AGENDA
BIG LAKE PLANNING COMMISSION MEETING
COUNCIL CHAMBERS

JULY 1, 2020

Prepared By: Amy Barthel, City Planner	Meeting Date: 7/1/2020	Item No. 7A
Item Description: Public Hearing for the Preliminary Plat, Conditional Use Permit and Site Plan for Nystrom Treatment Facility	Reviewed By: Hanna Klimmek, Community Development Director	
	Reviewed By: Clay Wilfahrt, City Administrator

SITE PLAN
C2-1

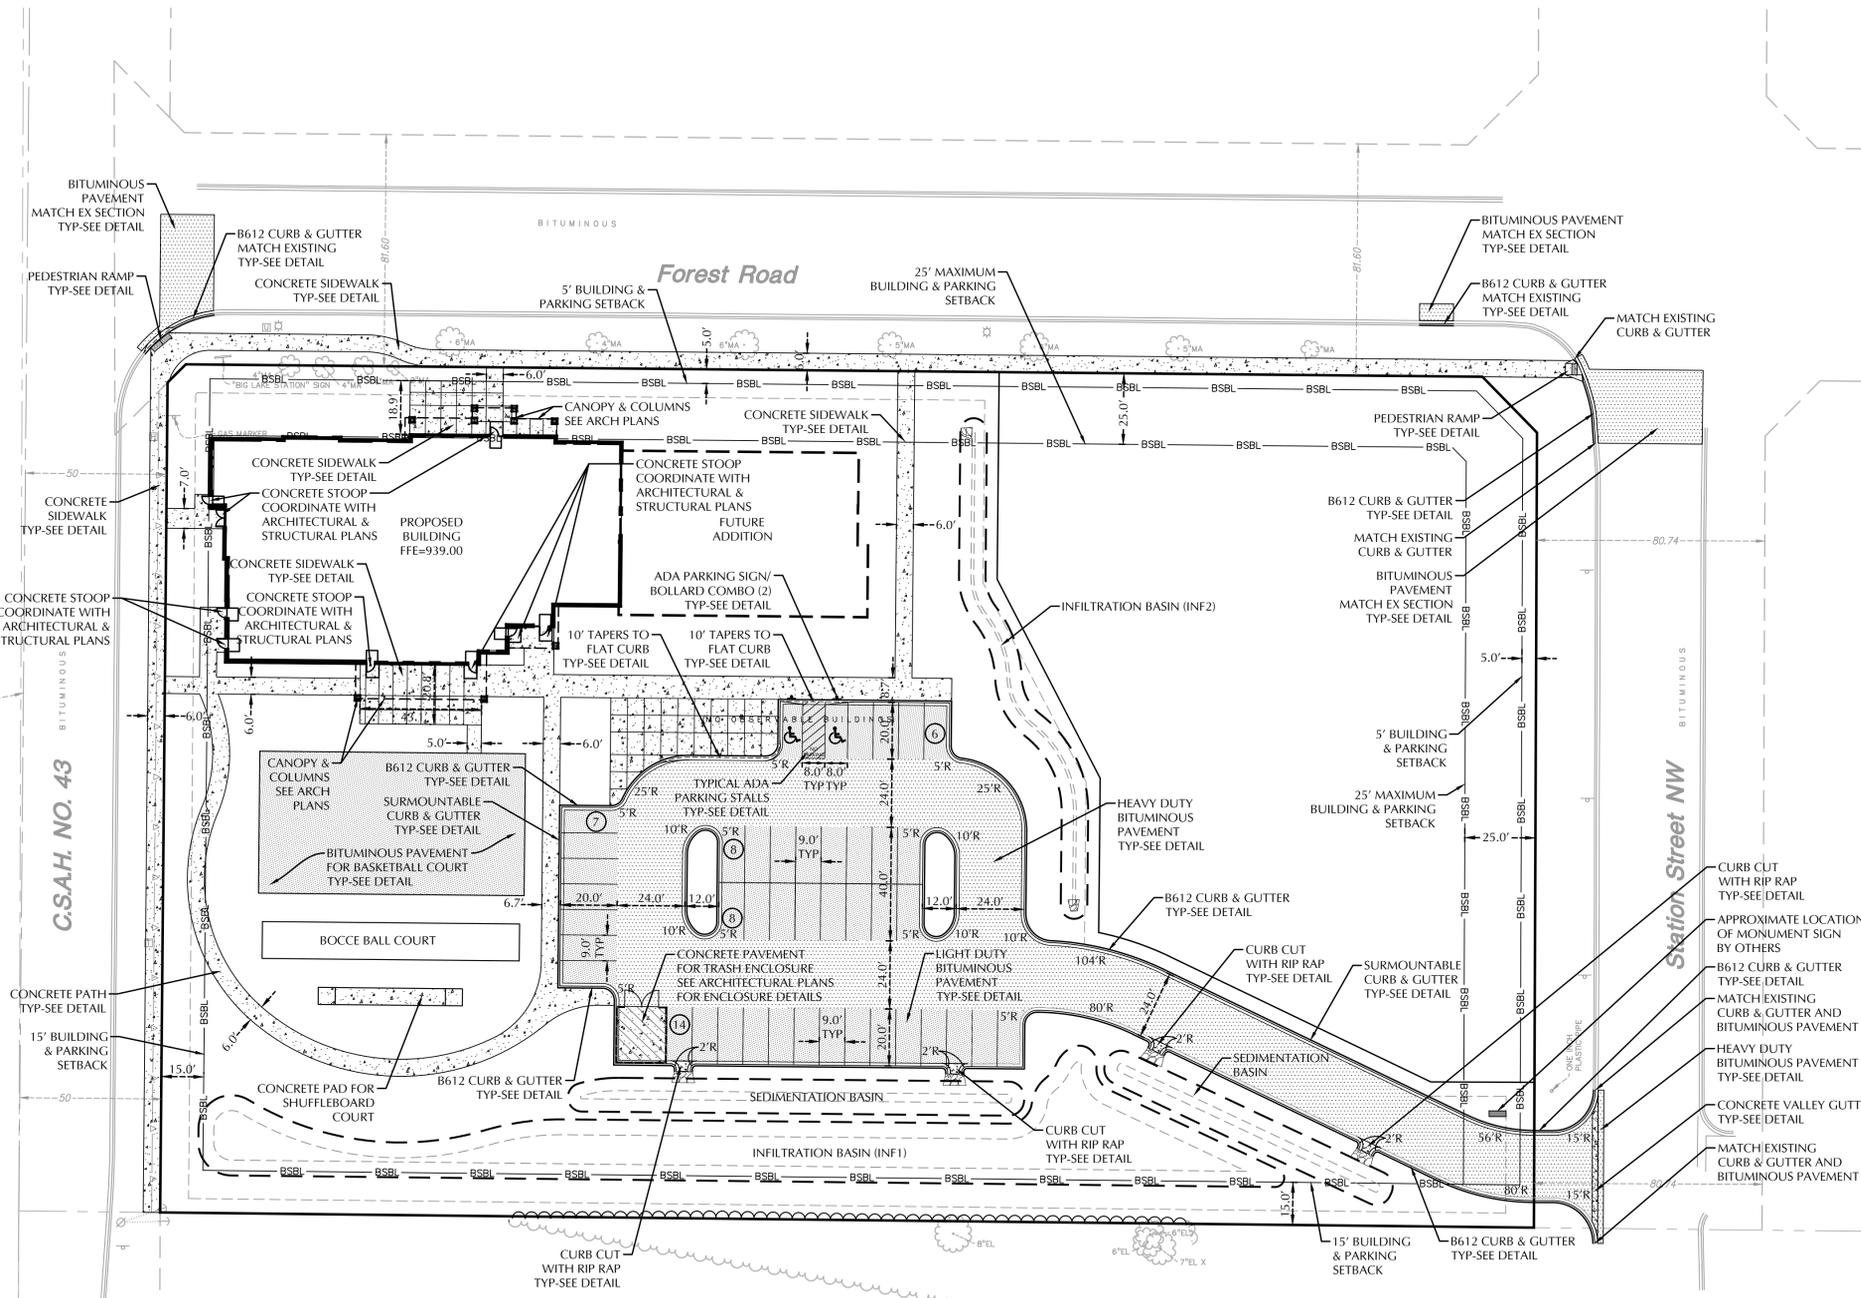
The parking plan shows forty-three (43) parking spaces for the property, including two (2) accessible spaces. According to City Code Section 1030.11 Subd.13, there is a requirement for Long-Term Care and Physical Disability Housing which can be considered as the same as the proposed facility with the difference being short-term versus long-term care. The parking ratio for the use requires a total of twenty-four (24) parking stalls. The TOD zone states that the number of parking stalls shall not exceed 104 stalls [Section 1068.04] which reads "Not more than one (1) parking space per one hundred (100) square feet of gross building area".

TOD requires certain parking standards including parking lot location, landscaped parking islands, screening, bicycle racks and walkway connections. Those standards have been analyzed and the following was found to be inadequate. The Applicant must resubmit plans including the following details pertaining to the parking requirements:

The installation of a landscaped island will most likely reduce the number of parking stalls down to forty-two (42) stalls. Staff will reevaluate the parking when the plans are resubmitted.

Sidewalks are required to be placed along all public right-of-way and be no less than six (6) feet in width [Section 1068.05 Subd.4]. The Applicant is showing improvements along County Road 43 and Forest Road in addition to the interior sidewalks. Light fixtures and pedestrian amenities including benches, public art, planters and the like shall be located along sidewalks or plaza areas. The Applicant will incorporate these types of amenities with the resubmitted plans. Staff expects to see lighting and benches in the plaza area as well as the internal walkways.

1. Address any outstanding engineer comments dated June 16, 2020.
2. The landscape plan shall be altered to include one (1) landscaped parking island to break up the ten (10) contiguous parking stalls.

3. The plans shall be altered to include a bicycle rack for the Subject Property.
4. Outdoor amenities such as pedestrian lighting and benches shall be added to the site plan per Section 1068.06 Subd.1(1)(b).

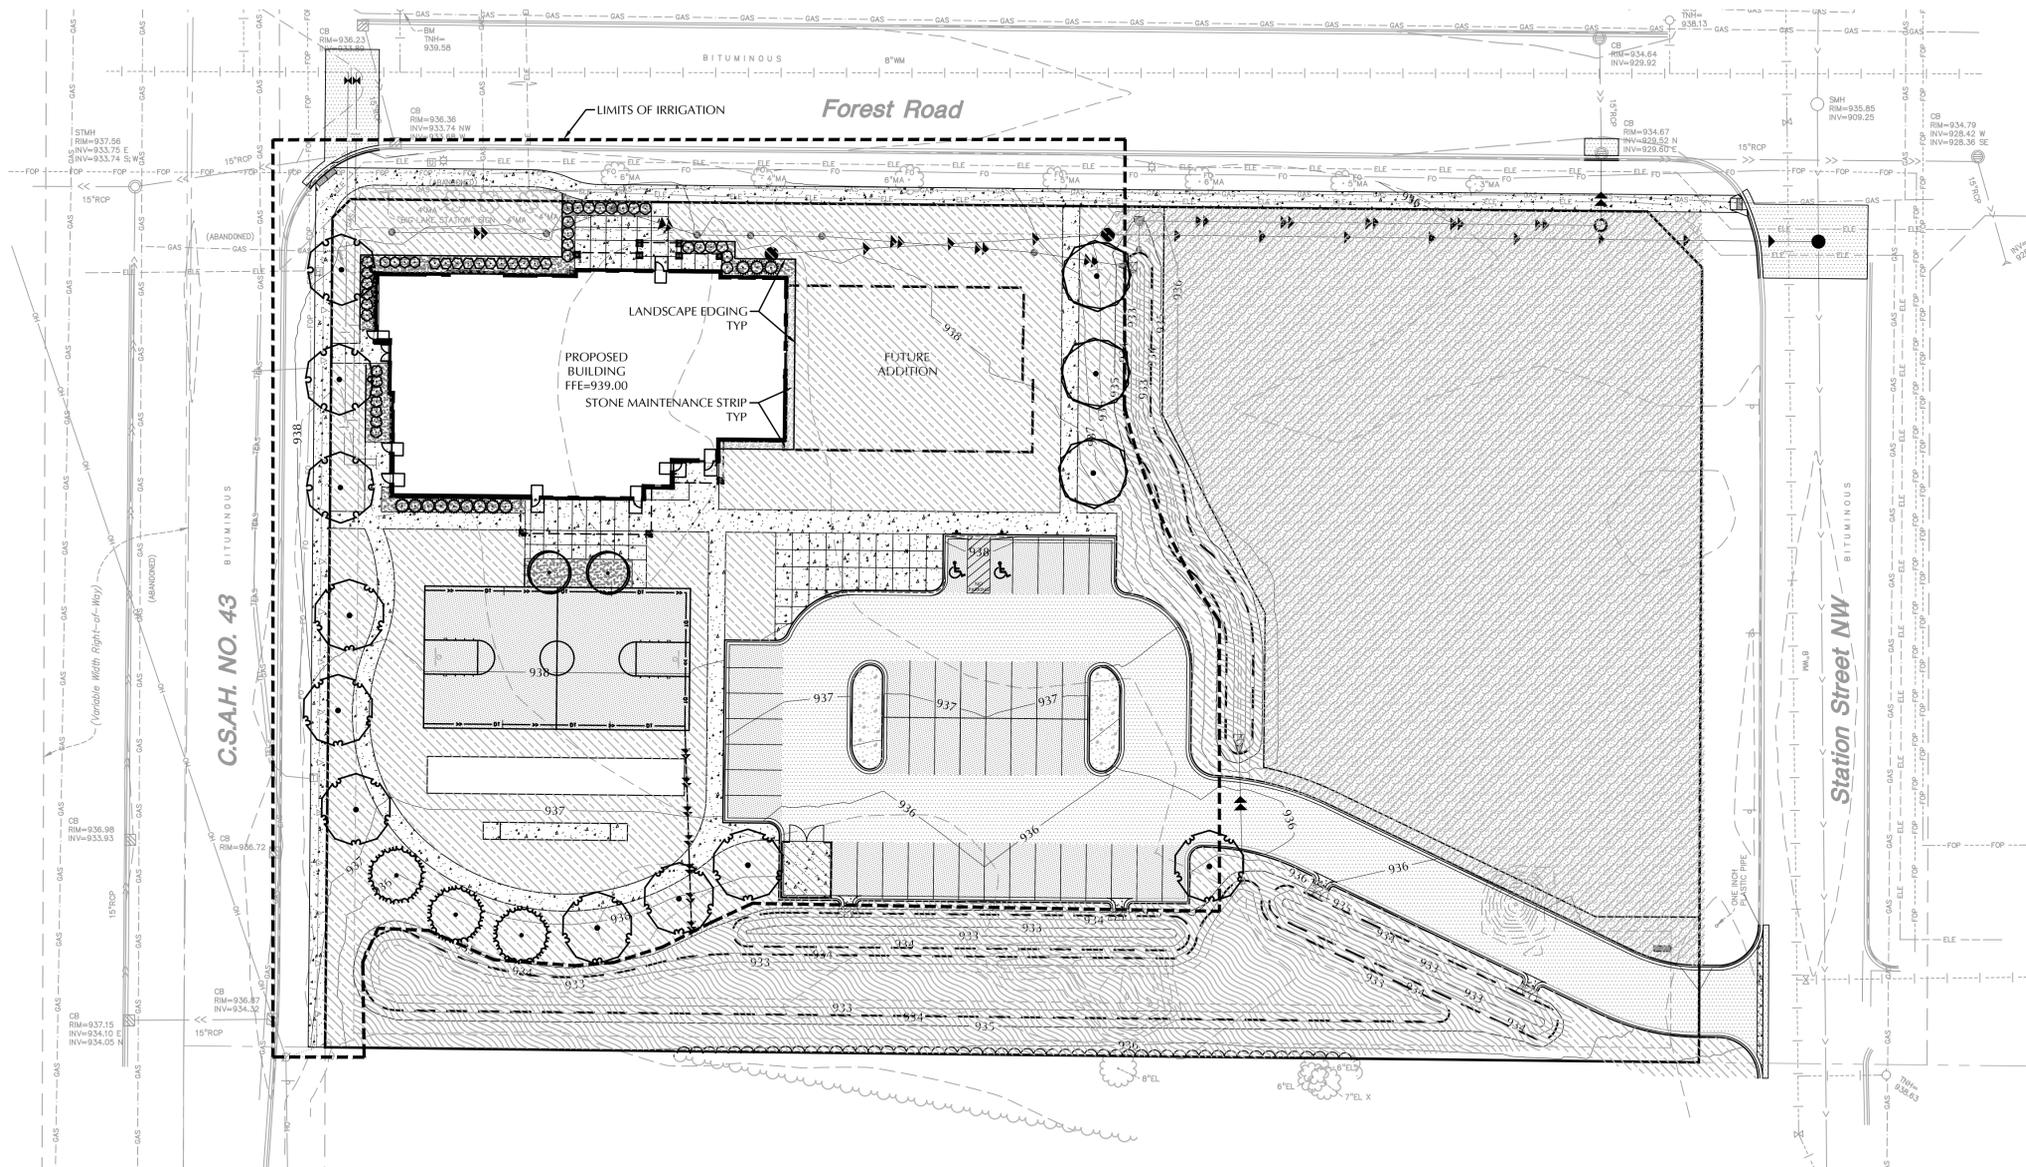
The parcel has been used for farming purposes and has few trees of significance existing on the property. Any trees will be removed from the Subject Property except for existing boulevard trees abutting Forest Road. For landscaping, City Code requires a specific size and species of tree and plants. The landscape plan shows eighteen (18) trees and fifty-one (51) shrubs around the property, all which are approved species. Below outlines the required number of plantings versus the proposed planting.

Code states that the complement of trees fulfilling the requirements of this Section shall be not less than twenty-five (25) percent deciduous and not less than twenty-five (25) percent coniferous. The Applicant has enough trees proposed to meet that requirement, but needs to add more coniferous trees to reflect that, which would require at least nine (9) trees deciduous and nine (9) trees coniferous.

Landscape plan requirements need to be adjusted.

5. The landscape plan shall include nine (9) coniferous trees and nine (9) deciduous trees are required.
6. The planned expansion for the facility will require a site plan amendment at which point parking and stormwater calculations will be evaluated.
